ON-SITE SEWAGE DISPOSAL SYSTEM HOWARD COUNTY HEALTH DEPARTMENT BUREAU OF ENVIRONMENTAL HEALTH

Fogles Septic Clean, Inc IS PERMITTED TO INSTALL ☒ ALTER ☐
ADDRESS: 580 Obrecht Road, Sykesville PHONE NUMBER: 410-795-5670
SUBDIVISION: Sand Hill Acres LOT NUMBER: 8
ADDRESS: 2415 Sand Hill Road PROPERTY OWNER: Steve & LaTonya Watson
SEPTIC TANK CAPACITY (GALLONS): 1250 OUTLET BAFFLE FILTER REQUIRED ☐
PUMP CHAMBER CAPACITY (GALLONS): 1250 COMPARTMENTED TANK REQUIRED ☐
NUMBER OF BEDROOMS: 4
SQUARE FEET PER BEDROOM: 180
LINEAR FEET OF TRENCH REQUIRED: 240

LOCATION DRAWING

Property Address: No. 2415 SAND HILL ROAD & NE SIDE LAMPLIGHTER'S DRIVE
LOT 8 SECT. 3 AREA 1 LOTS 6 THRU 11
SAND HILL ACRES PLAT # B355
3RD DIST. HOWARD COUNTY, MD

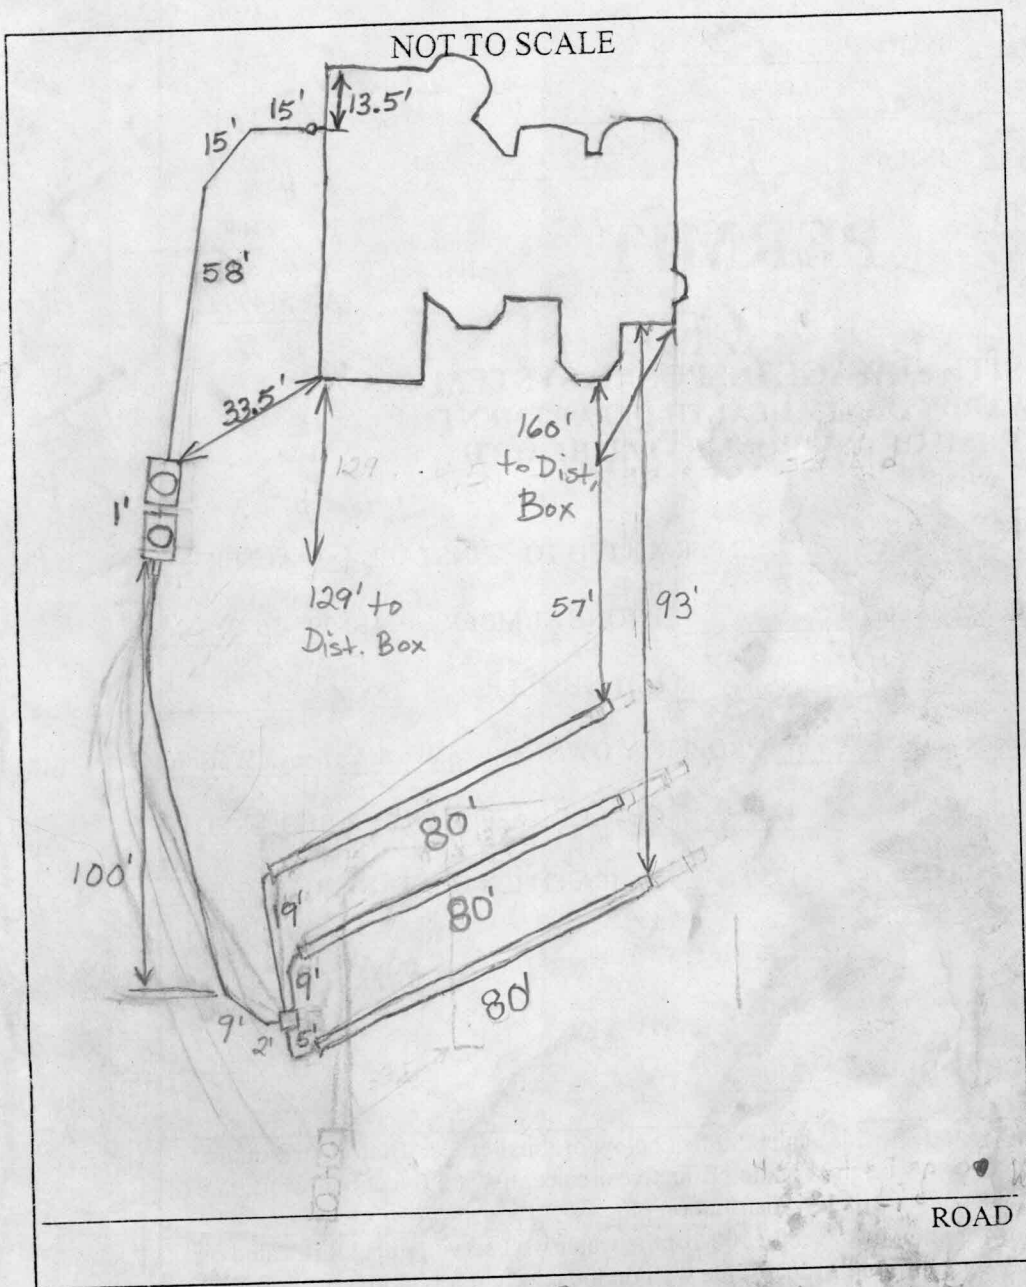
PRE-CONSTRUCTION 7/15/04 Easement staked incorrectly. Surveyor to restake and Fiegles to call in for another layout.

INSTALLATION Top of septic tank riser lids are 4.5' above tanks. Final grade should be about 1.5' below top of lids. (BB)

8/3/04 Layout cancelled. Stopped at site. Trench locations staked out but easement not staked. (BB) 8/5/04 Easement needs to be staked out. Could not do layout. Is driveway going over easement? (BB) 8/17/04 Surveyor called (David Ransone). I explained to him that whole easement needs to be staked out so that we can do proper layout. (BB) 8/23/04 - SRA staked, install

(3) 80' trenches per BP (Sc)

HOUSE MOVED
20' TO RIGHT
NO IMPACT TO WELL OR SEPTIC
OK MR
4/17/02
